Re: Washingtonian North – SDP-3878-2013 (the “SDP”)

Joint Hearing - MCC & PC
SDP-3878-2013
Exhibit #89

SUBJECT: Staff Analysis:
SDP-3878-2013
Washingtonian North
Schematic Development Plan
10000 Block of Washingtonian Boulevard

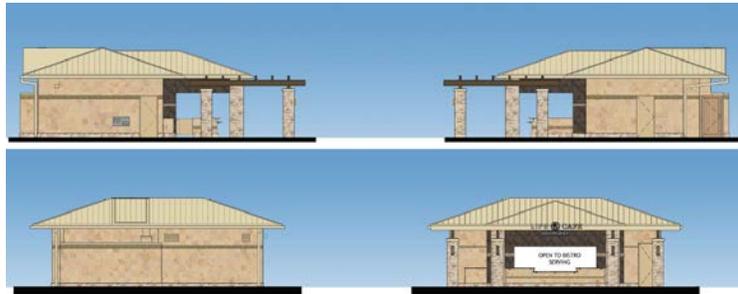
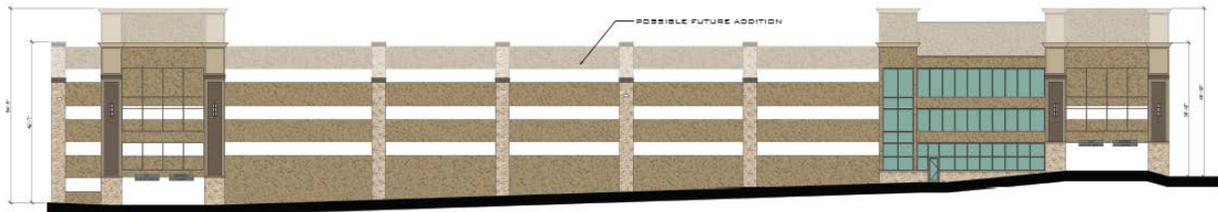
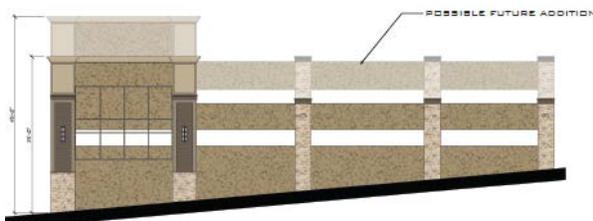
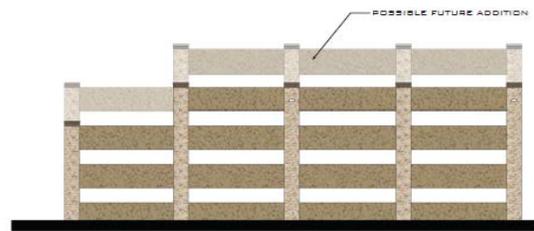
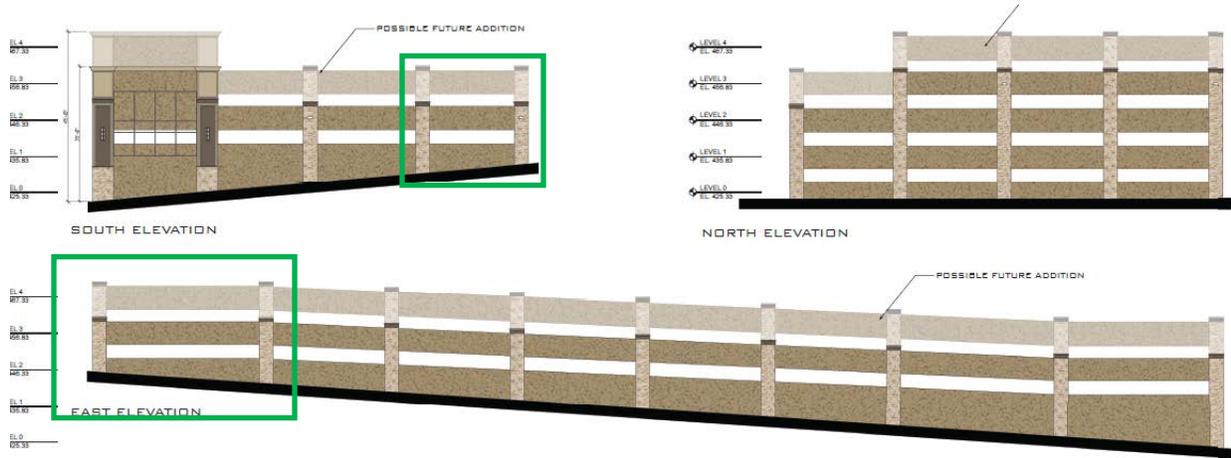
Staff would recommend that a condition of the SDP approval be that prior to the submission of Final Site Plan, Boston Properties review elevations and materials of the garage to create a more distinctive façade.

Staff would recommend the installation of a green screen or revised architectural elevations on the south and east elevations of the LifeTime Fitness garage shown in the boxes below. A condition related to the architectural elevations of the garage has been added.

- 20) Applicant to provide distinctive architectural elevations of the office and health club garages at the time of final site plan.
- 21) Prior to the submission of any Final Site Plan applications, the applicant shall obtain approval of the Utility Plan from all utilities.

Joint Hearing - MCC & PC
SDP-3878-2013
Exhibit #94

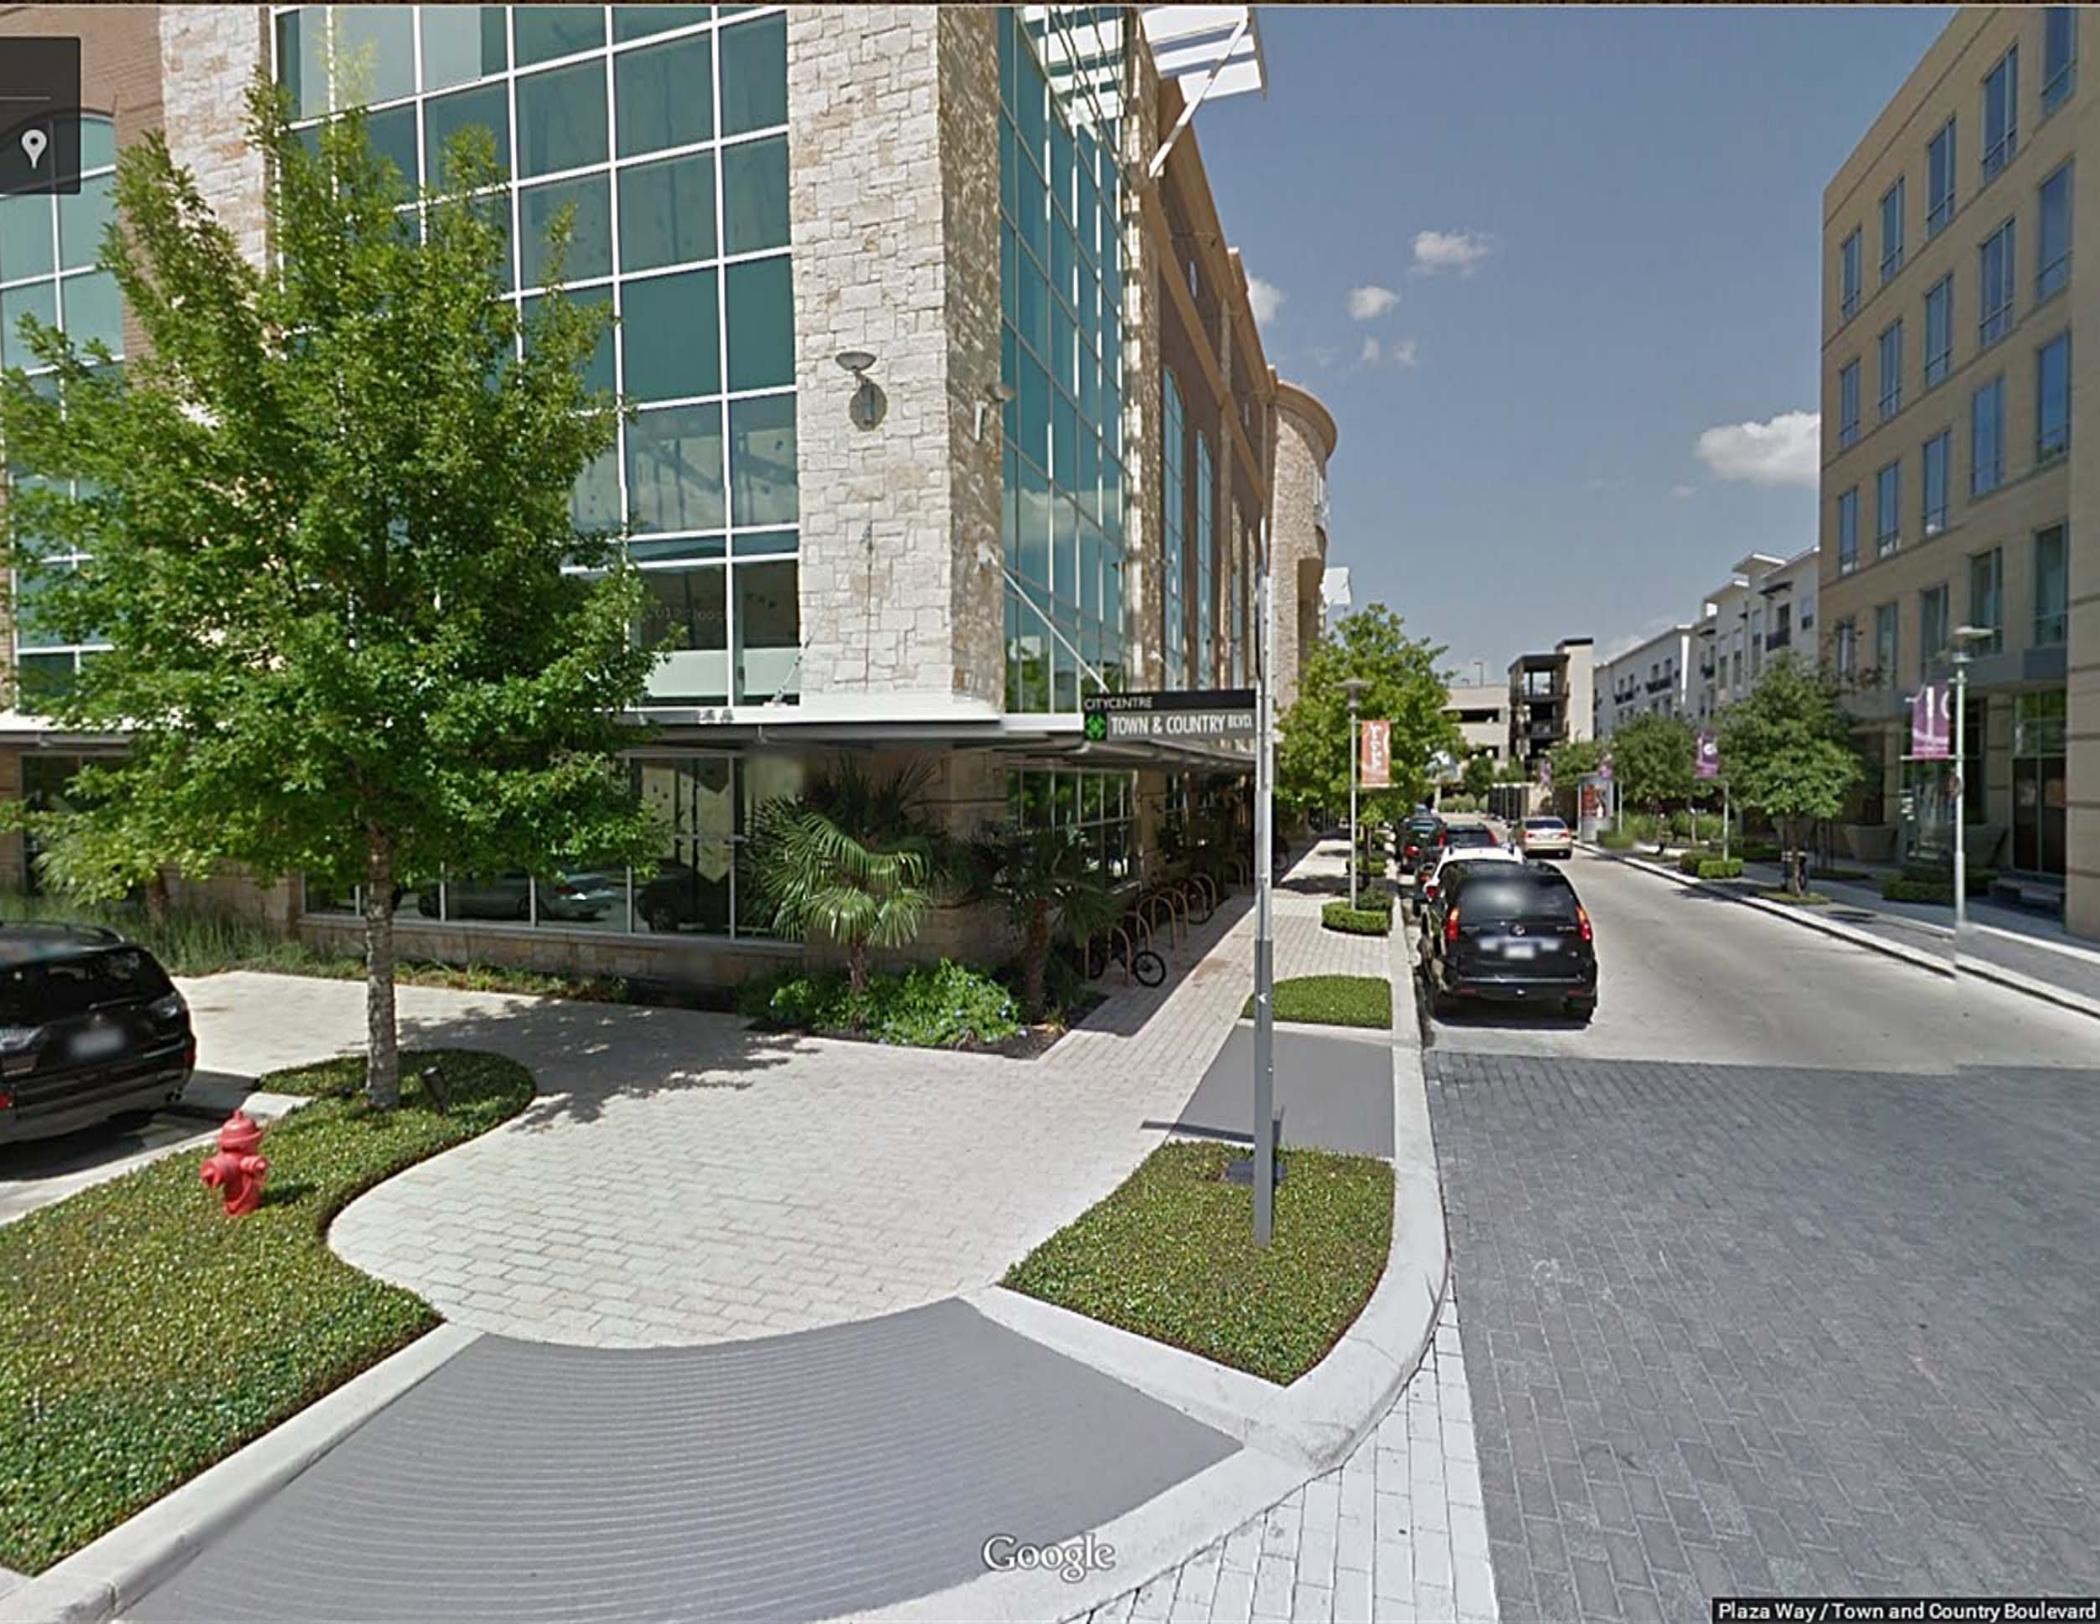
Unfortunately, the site orientation for the buildings and circulation plan likely will produce a more dead end, dead street environment that will encourage driving to the site rather than improving this important connection.

Changes to bring the site more in line with the TND cited in the MXD code would include:

1. Change the orientation for the front of the Lifetime Fitness Building from Sam Eig to the interior street facing the apartment building. If there is a desire to have an entrance face Sam Eig then a primary entrance should still be developed across from the residential building.

2. Change the orientation for the main entrance to the residential building to be across from a reoriented Lifetime Fitness building front entrance.
3. Once the buildings are facing each other and drawing traffic to each other to enliven the street, place the actual street and surface parking between the buildings rather than far apart from each other in auto oriented strip mall type placements.

4. Remove the surface parking near Sam Eig for Lifetime Fitness and bring it onto the interior street between the residential and Lifetime Fitness building. Combine the two interior roads into one between the two buildings and place the parking in the center along a median. A configuration like this worked very well in Leesburg Town Center for example (see below).
